Report of Staff Recommendation

File No.: 4-B-22-TOB

TO: TTCDA Review Board
From: Arthur Long / CML Property Group for Wakefield Development
DATE: March 15, 2022
SUBJECT: Waiver Requests for 4-B-22-TOB / 4-F-22-SU – Self Storage
ADDRESS: 10320 Dutchtown Rd (Parcel ID: 118 17606)

New Self Storage Facility **Proposed Storage** 10320 Dutchtown Road Knoxville, TN

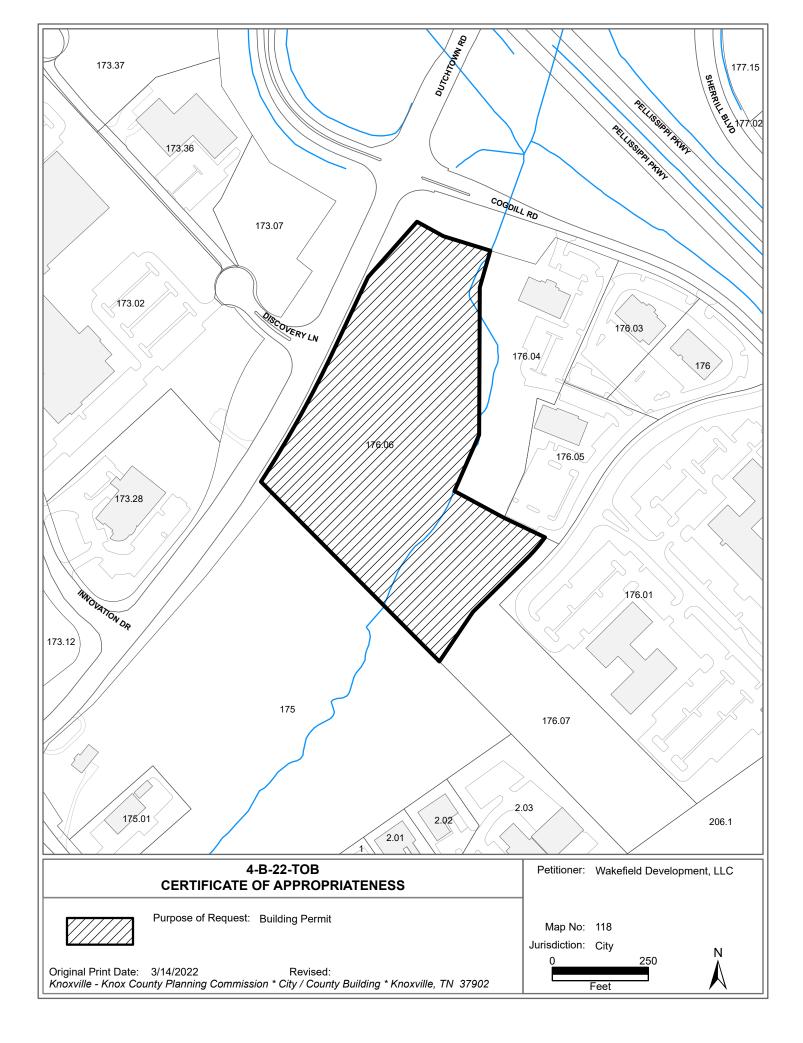
2) Approval of a final plat subdividing the property as shown in Sheet PL01.

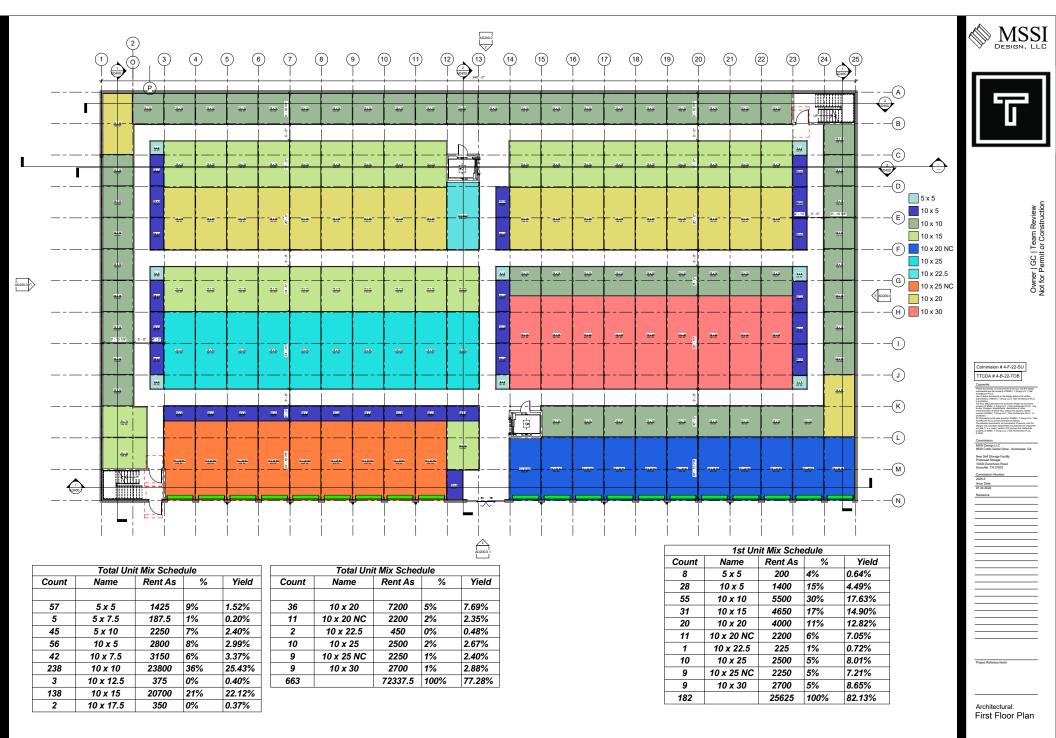
3) Installation of all landscaping as shown on development plan within six months of the issuance of an occupancy permit, or posting a bond with the City of Knoxville Engineering Department to guarantee such installation.
